**Veterans Administration
2121 N. Avenue
Grand Junction, CO 81501
RE: Boiler House
100,000 Gallon E.W.T.
May 17, 2013
Doyle Payne,
Assistant Chief Engineering Service
(970) 242-0731 ext. 2099
Job No. 313195**

ELEVATED TANK INSPECTION REPORT

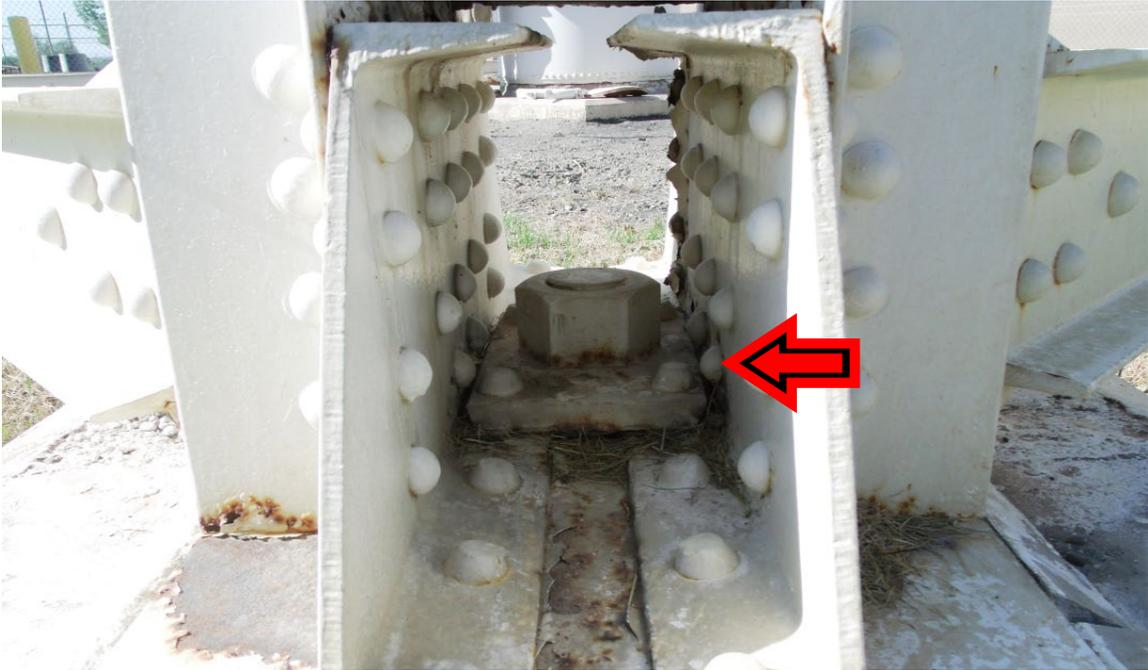
Photo shows the condition of the foundations. We recommend removing all dirt, debris and loose gravel from the foundation, repairing any cracks and spalling in the concrete with a commercial non-shrinking grout and sealing the foundation with a sealant.

We also recommend the tank be electrically grounded for lightning protection as required by [OSH Act 29 CFR 1926, Subpart K](#).

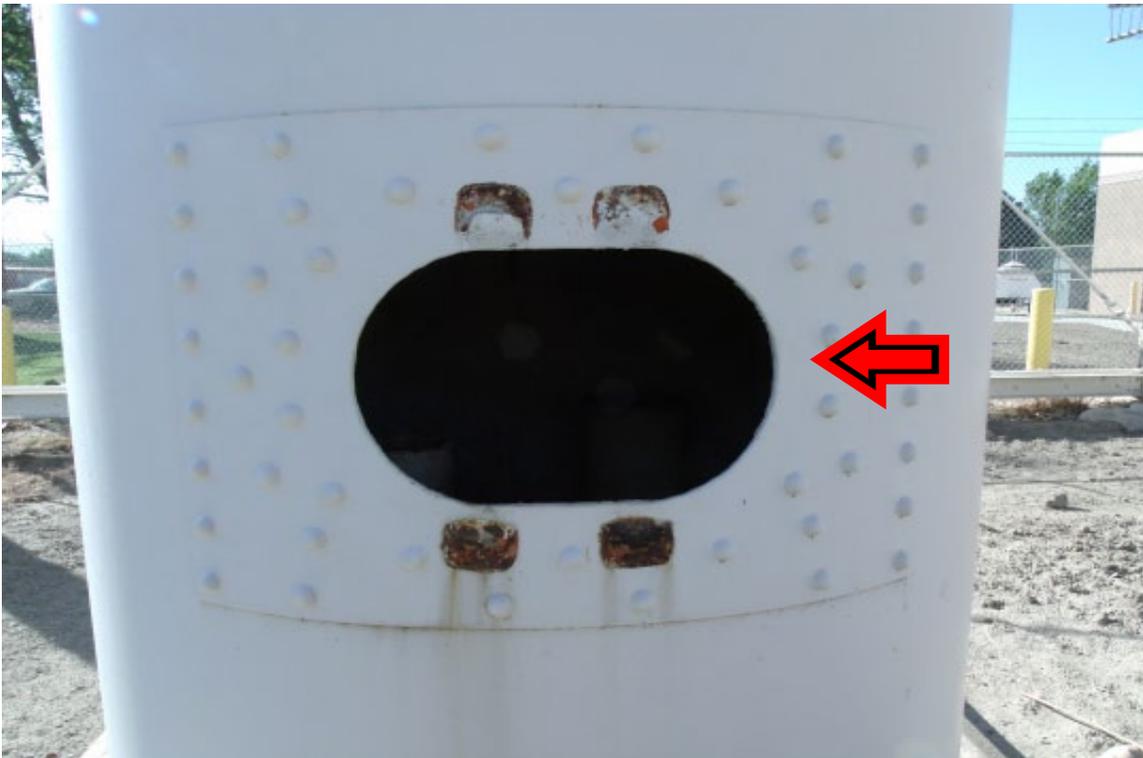
Photo shows the condition of the riser manway. This manway would restrict entry in an emergency. We recommend replacing the existing riser manway with an **AWWA D100-11: 5.4.4** approved 24" manway, complete with a davit arm, a **Confined Space Entry** sign and maintenance free galvanized steel bolts.

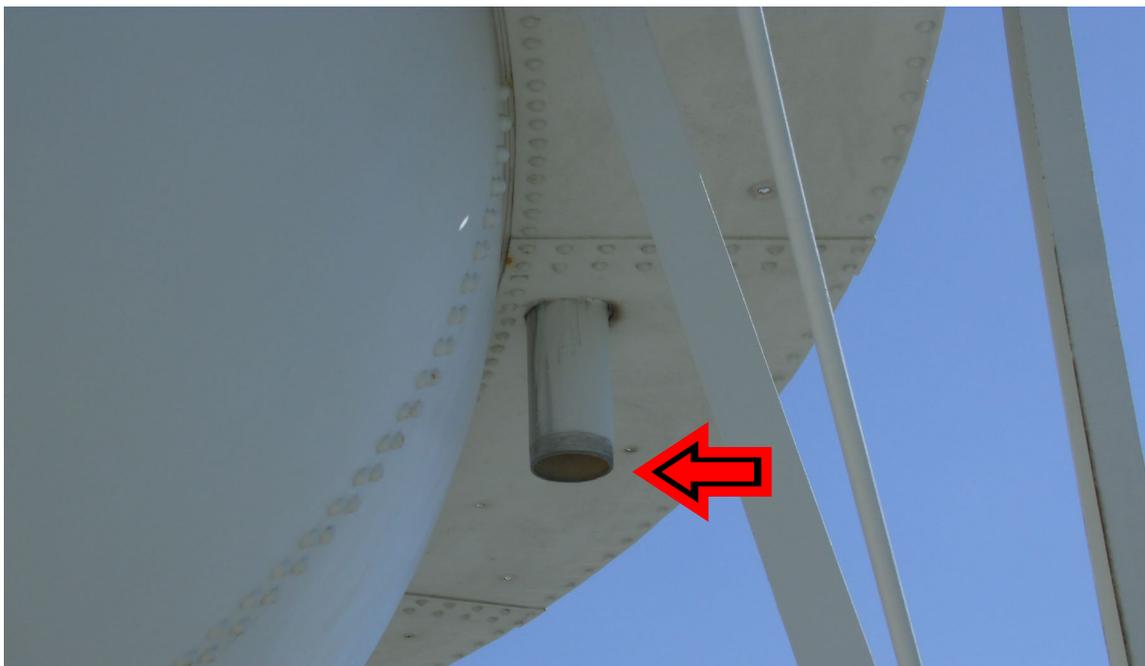
Photo shows the inlet and outlet pipes in the base of the riser pipe. We recommend installing a protective plate over the outlet pipe, supported over the pipe by three 1/2" x 1" standoffs 12" long. This will prevent silt from falling into the pipe from the tank bowl.

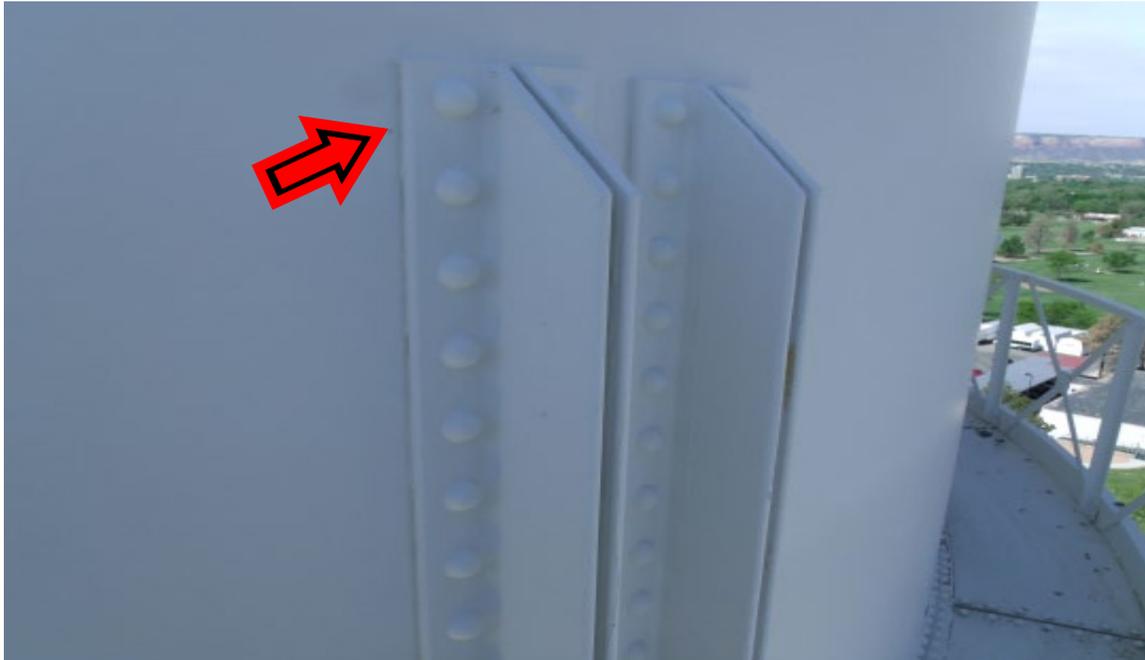
Photos show the condition of the posthead connections. The postheads secure the column legs to the tank shell and support the tank's live and dead load. We recommend welding the circumference of the posthead-to-shell connection for reinforcement.

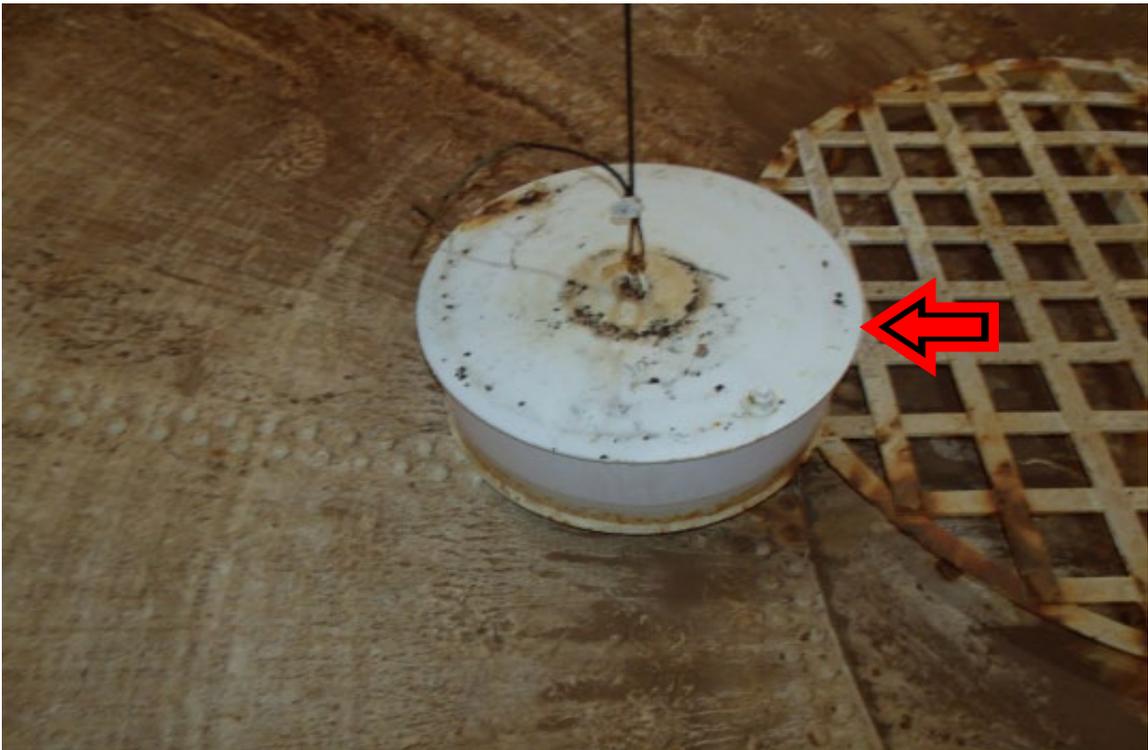
Photos show bird feathers on the tank catwalk. We recommend applying a commercial bird repellent on the tank to discourage birds from roosting in the treated area.
